ADDENDUM NO. 4:

Date: February 13, 2026
 Project: Verbena HS Gym
 DCM# 2025629
 WSM# 25-032

Owner: Chilton County Board of Education
 Architect: Ward Scott Morris Architecture, Inc.

PROJECT: Verbena HS Gym	ENG #2559 ARCH #25-032 DCM #2025629	DATE: February 13, 2026
-----------------------------------	---	-----------------------------------

F101

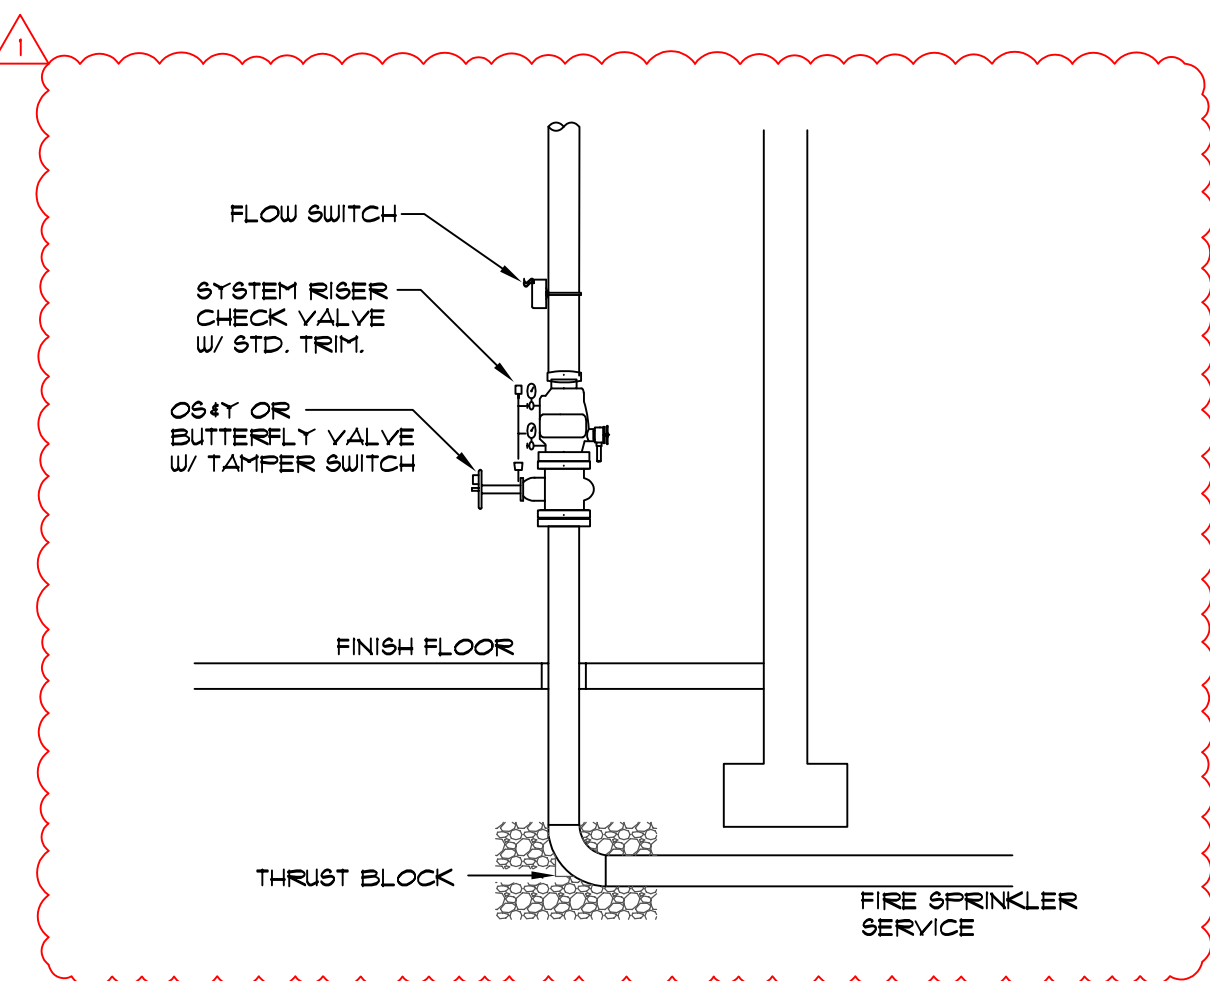
1. Sheet F101: Delete fire pump. New water service to area provides 75 PSI static on 8" line. No flow test has been performed.
2. Sheet F101: Relocate fire service entrance to Riser 1109.

P001

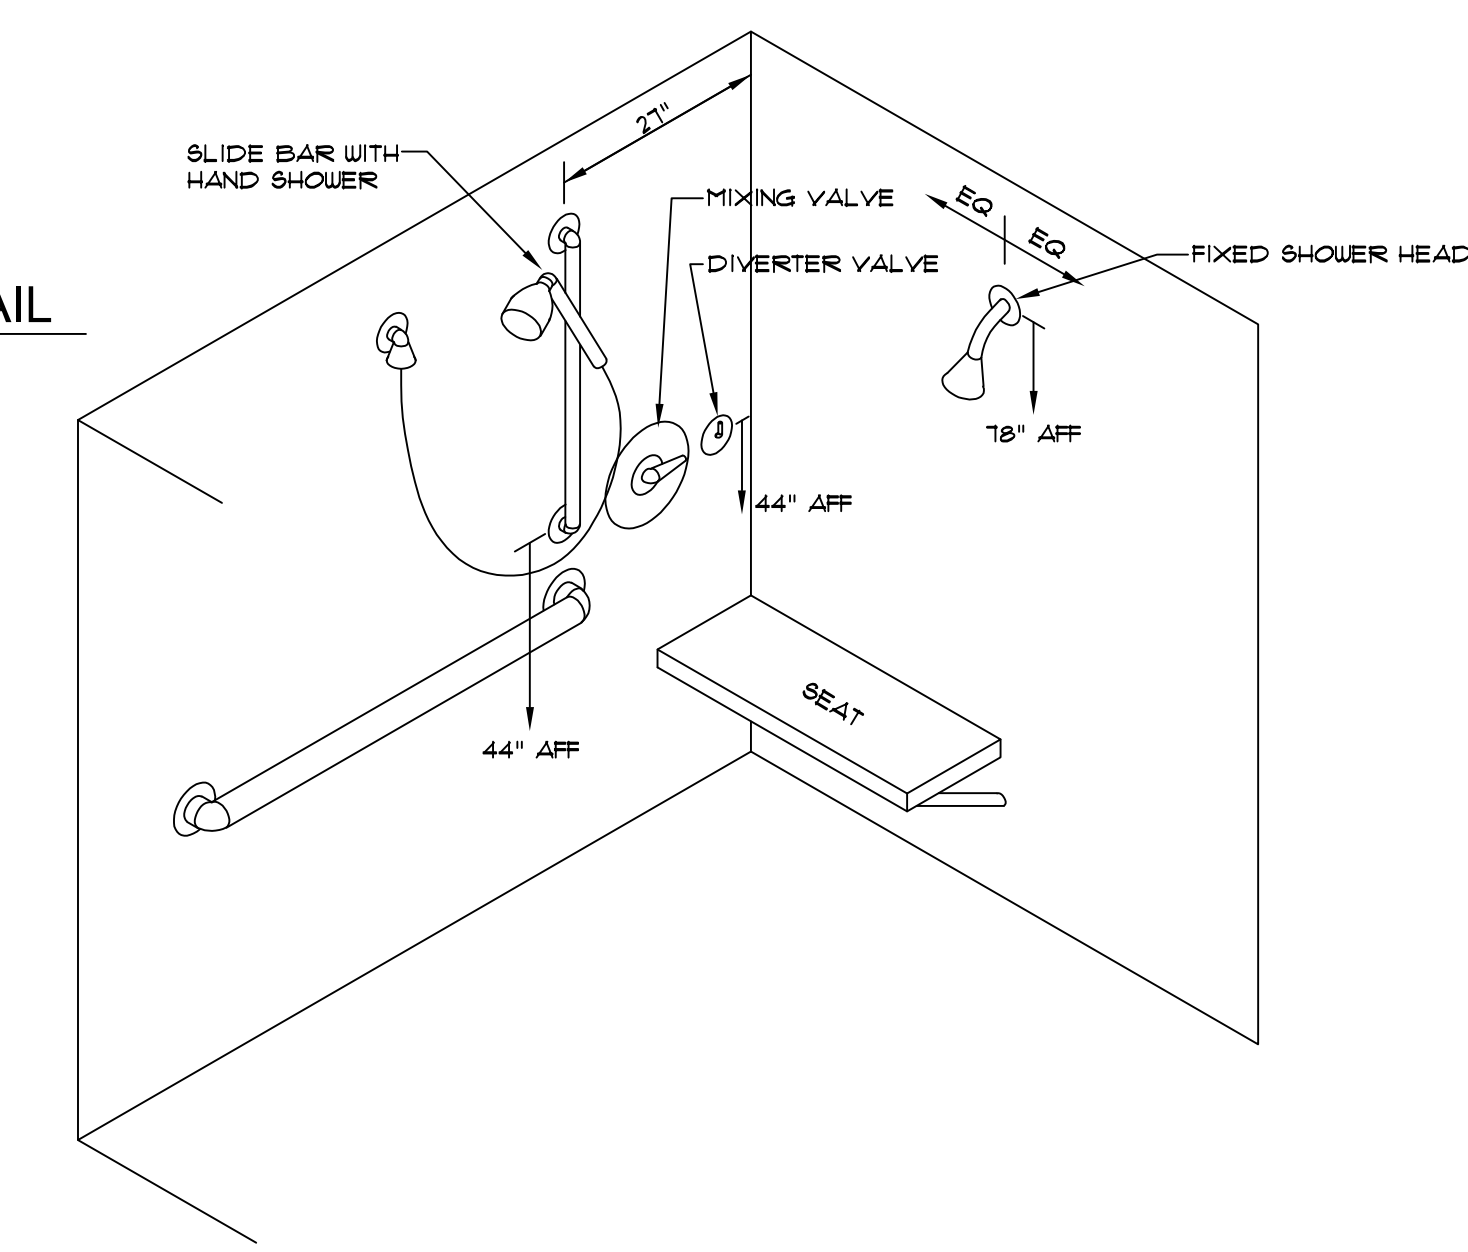
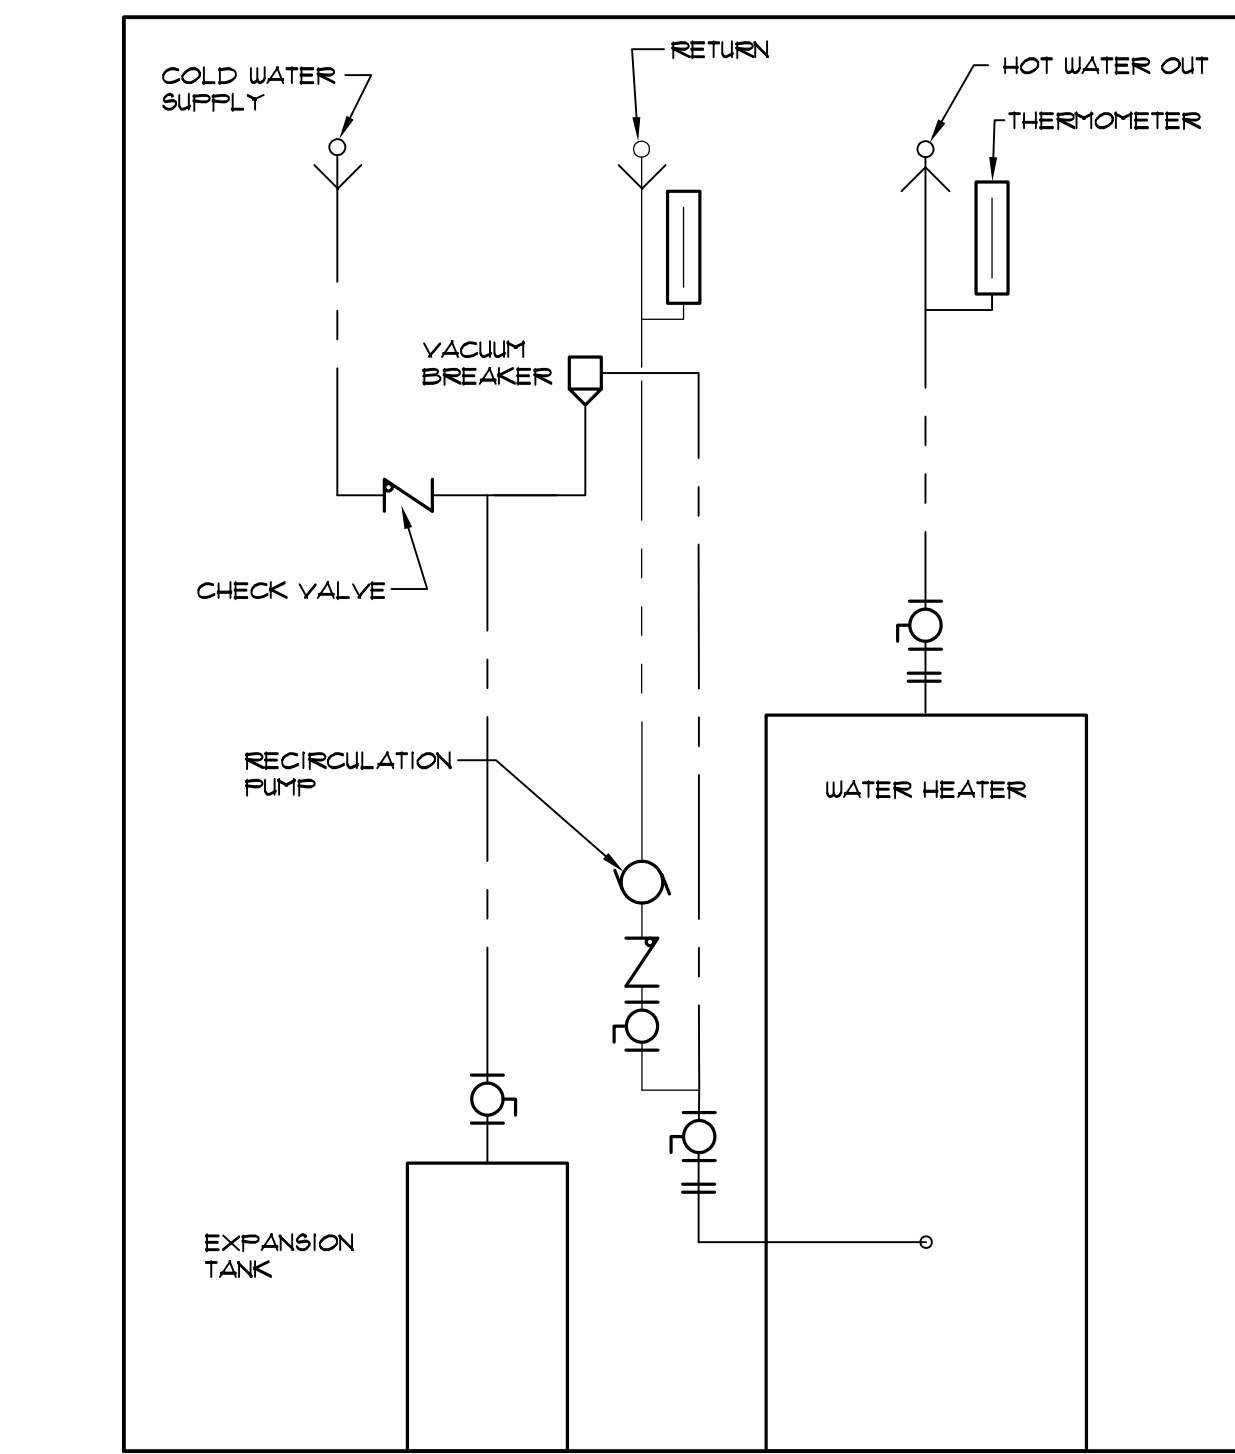
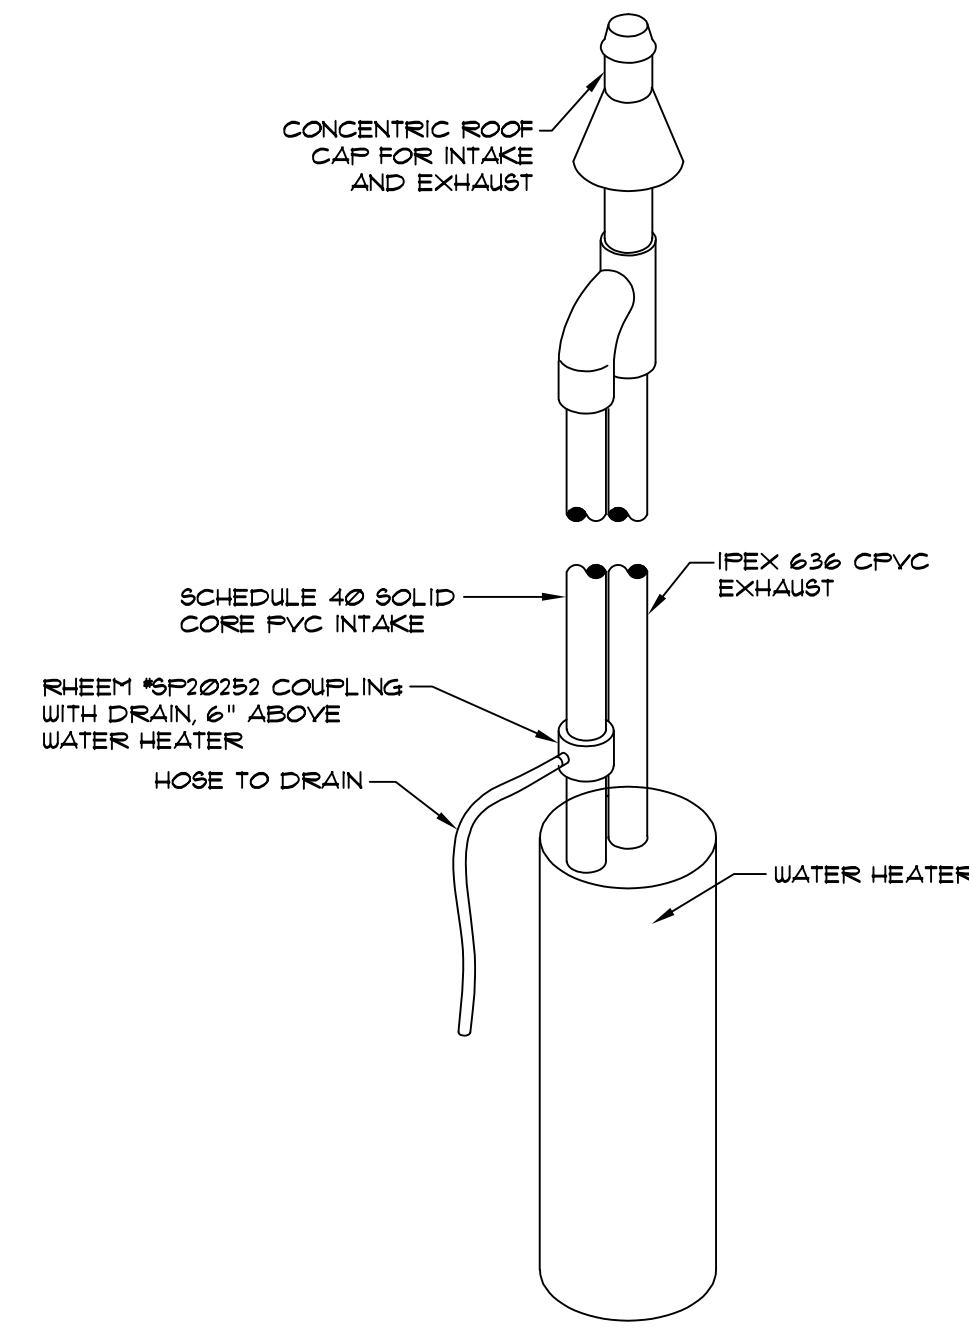
1. Sheet P001: P-17 is recirculating pump for domestic water.
2. Sheet P101: Delete floor drain in former fire pump room.
3. Sheet P201: Delete pressure boosting pump. New water service to area provides 75 PSI.
4. Sheet P201: Relocate water service to Riser 1109
